R. R. Sgarro
Director - Regulatory Affairs

**BELL BEND NUCLEAR POWER PLANT
ENVIRONMENTAL AUDIT NEED FOR
INFORMATION RESPONSES:
FOURTH SUBMITTAL
BNP-2012-151 Docket No. 52-039**

Need for Information Responses

Figure 2.2-4— BBNPP Site Zoning Map

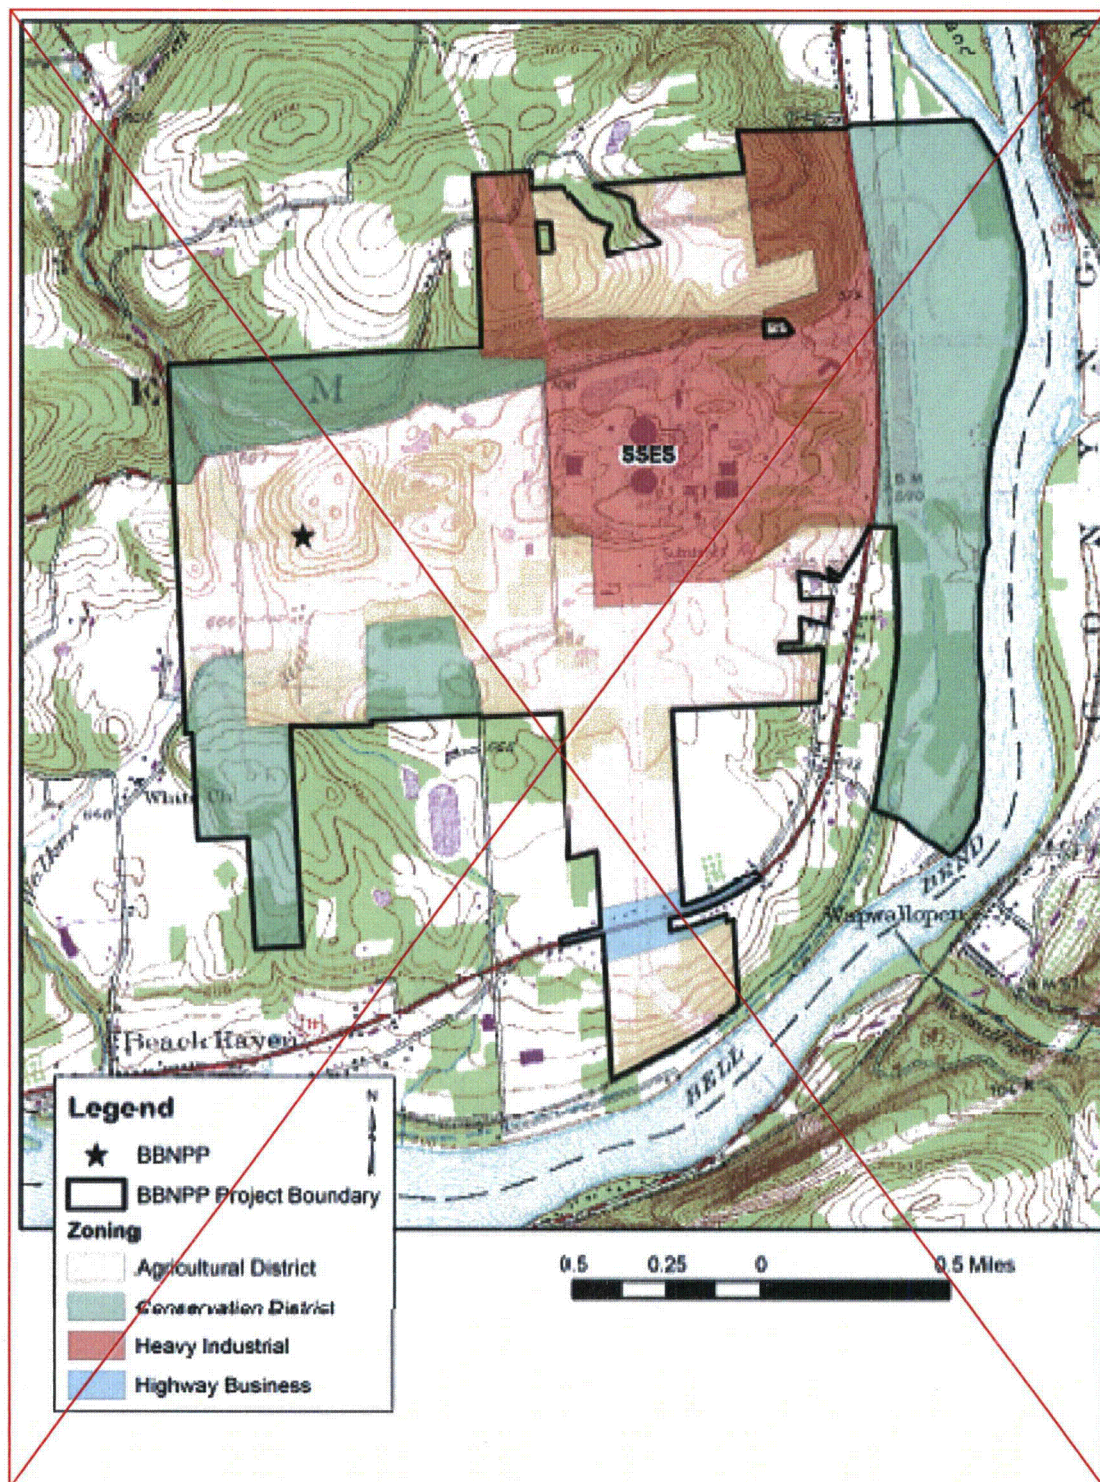
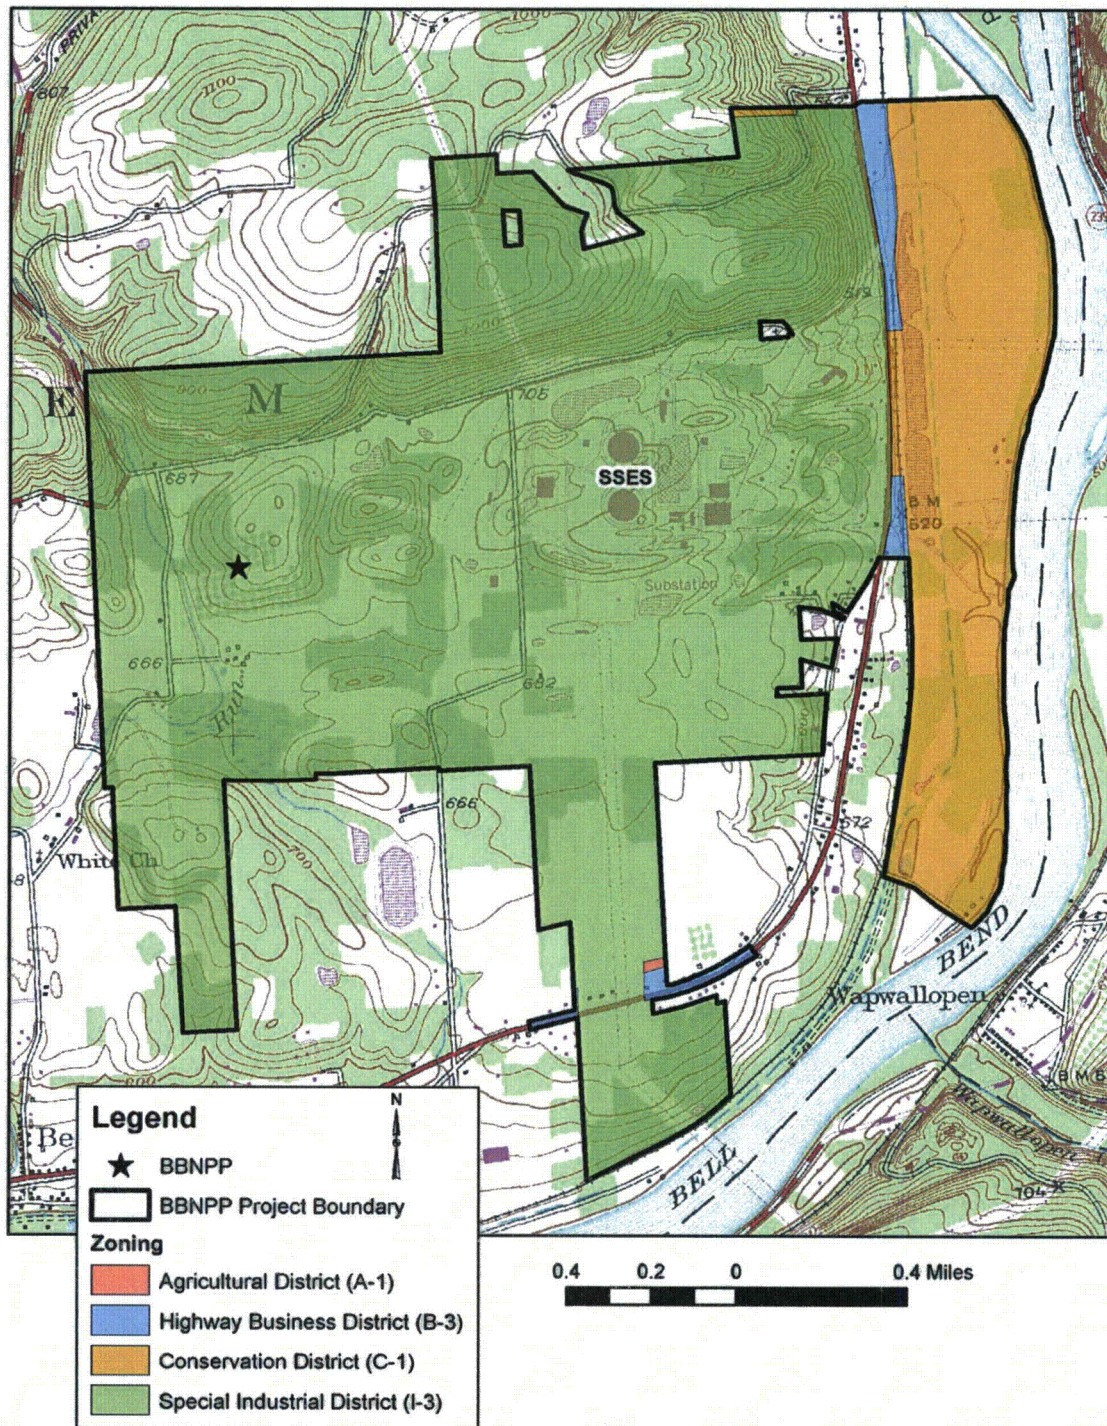
NFI LU-01: Discuss how and when the BBNPP parcel will be divided into west and east parcels under separate ownership.

Upon review of this NFI response, the NRC requested to be provided updated information on the status of zoning changes at the Bell Bend Nuclear Power Plant (BBNPP) site. Accordingly, an updated zoning figure will be included in a future version of the BBNPP Environmental Report (ER), Figure 2.2-4.

An updated ER Figure 2.2-4 has been created to incorporate the updated zoning information from Salem Township, and the ER narrative in Section 2.2.1 will be revised to describe the updated zoning information within the Project Boundary.

The BBNPP COLA ER Sections 2.2.1, 2.2.4, and Figure 2.2-4 will be changed in a future revision as described below.
